#### MPI Penalty for Optical PMDs

(Addressing comments 231, 232, 233, 234, 235)

IEEE 802.3dj Interim Meeting
Phoenix

**January 20, 2025**

# MPI Penalty for Clause 180

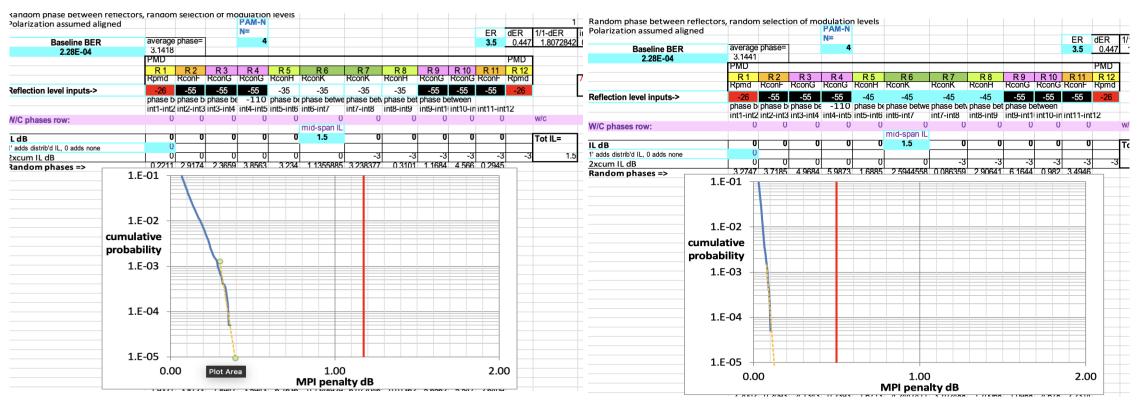
- ☐ Use 4 connectors with discrete reflectance of -35 dB for 200GBASE-DR and -45 dB for 400GBASE-DR2, 800GBASE-DR4, and 1.6TBASE-DR8 for mid-span channel IL=1.5 dB
  - 200GBASE-DR MPI penalty is ~0.4 dB +0.18 dB DGD, total penalty=0.58 dB, D1.3 MPI/DGP penalty= 0.1 dB
  - 400GBASE-DR2, 800GBASE-DR4, and 1.6TBASE-DR8 penalty is ~0.12 dB +0.18 dB DGD, total penalty=0.3 dB, D1.3
     MPI/DGP penalty= 0.1 dB.

## MPI Penalty for Clause 181

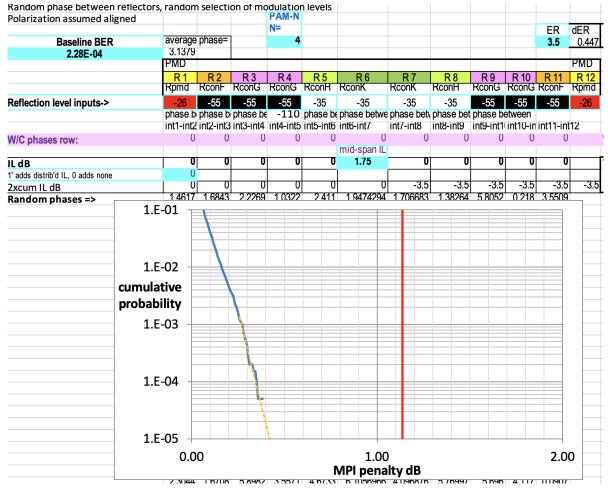
- Use 4 connectors with discrete reflectance of -35 dB for 800GBASE-FR4-500 for midspan channel IL=1.75 dB
  - MPI penalty is ~0.41 dB with addition of
     0.18 dB DGD penalty total penalty 0.59 dB
  - In the D1.3 MPI/DGD penalty= 0.5 dB

## MPI Penalty for Clause 182

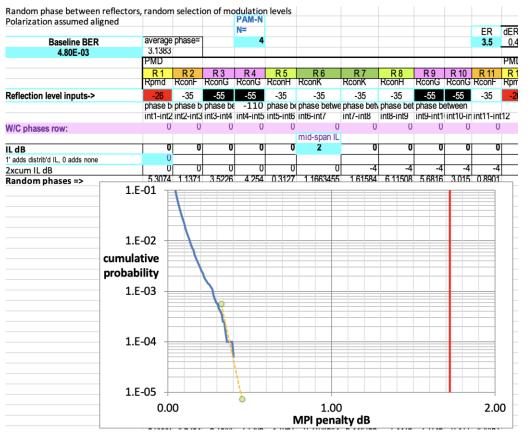
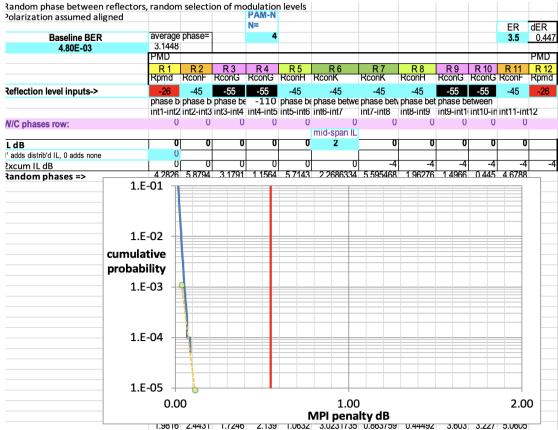
- ☐ Use 6 connectors with discrete reflectance of -35 dB for 200GBASE-DR-2 and -45 dB for 400GBASE-DR2-2, 800GBASE-DR4-2, and 1.6TBASE-DR8-2 with mid-span loss of 2 dB
  - 200GBASE-DR-2 MPI penalty is ~0.45 dB +0.18 dB DGD total penalty=0.63 dB, D1.3 MPI/DGD penalty= 0.4 dB
  - 400GBASE-DR2-2, 800GBASE-DR4-2, and 1.6TBASE-DR8-2 penalty is ~0.1 dB +0.18 dB DGD total penalty=0.28 dB, D1.3 MPI/DGD penalty= 0.4 dB.

#### Some Options to Reduce 200GBASE-DR-2 MPI Penalty

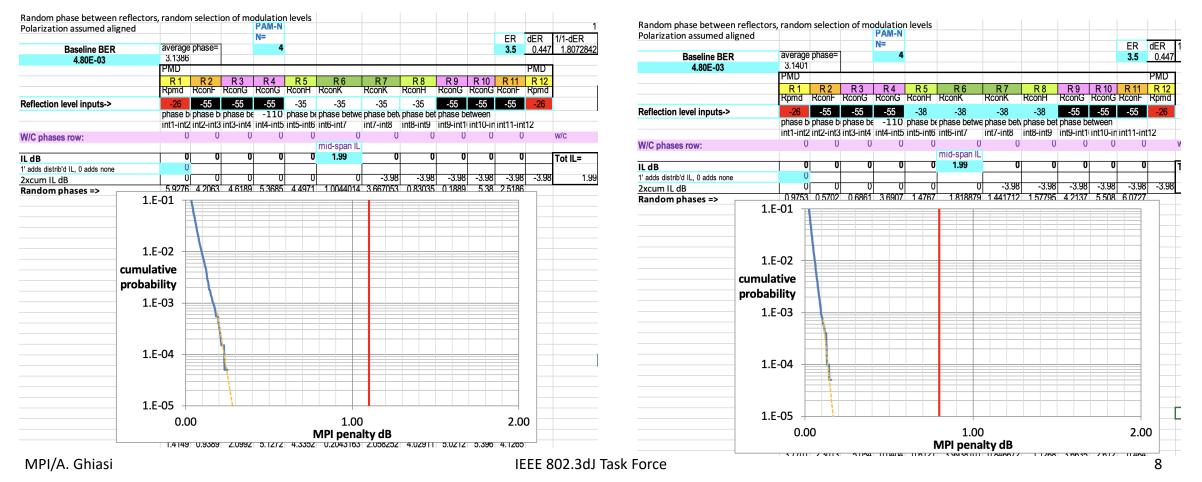
- Supporting 4 connectors at -35 dB then MPI penalty reduced to 0.28 dB with 0.18 dB DGD total penalty=0.46 dB
- Supporting 4 connectors at -38 dB then MPI penalty reduced to 0.17 dB with 0.18 dB DGD total penalty=0.36 dB

## MPI Penalty for Clause 183 800GBASE-FR4

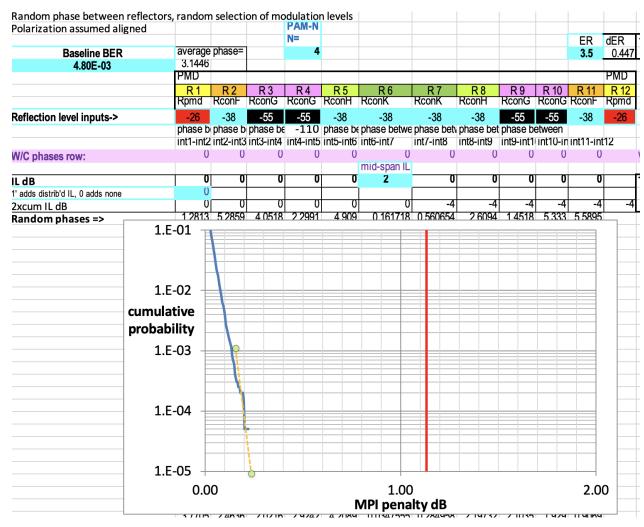
- Use 6 connectors with discrete reflectance of -38 dB for mid-span channel IL=2 dB
  - MPI penalty is ~0.23 dB with addition of 0.18 dB DGD penalty total penalty 0.41 dB
  - In the D1.3 MPI/DGD penalty= 0.5 dB

#### MPI Penalty for Clause 183 800GBASE-LR4

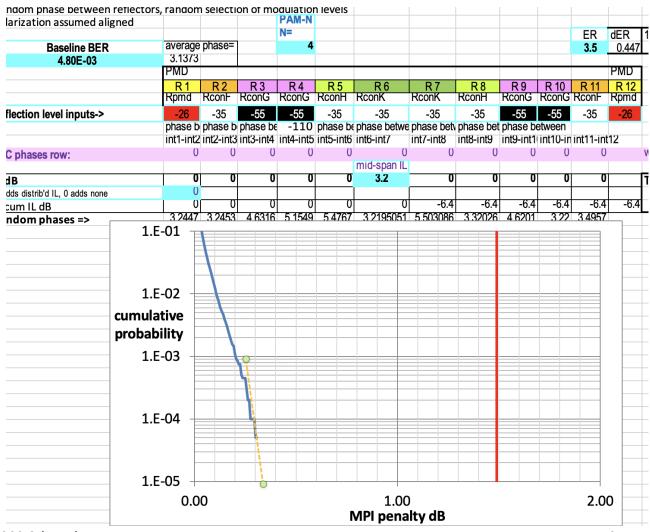
- Use 6 connectors with discrete reflectance of -35 dB for mid-span channel IL=3.2 dB
  - MPI penalty is ~0.32 dB
  - In the D1.3 MPI penalty= 0.4 dB
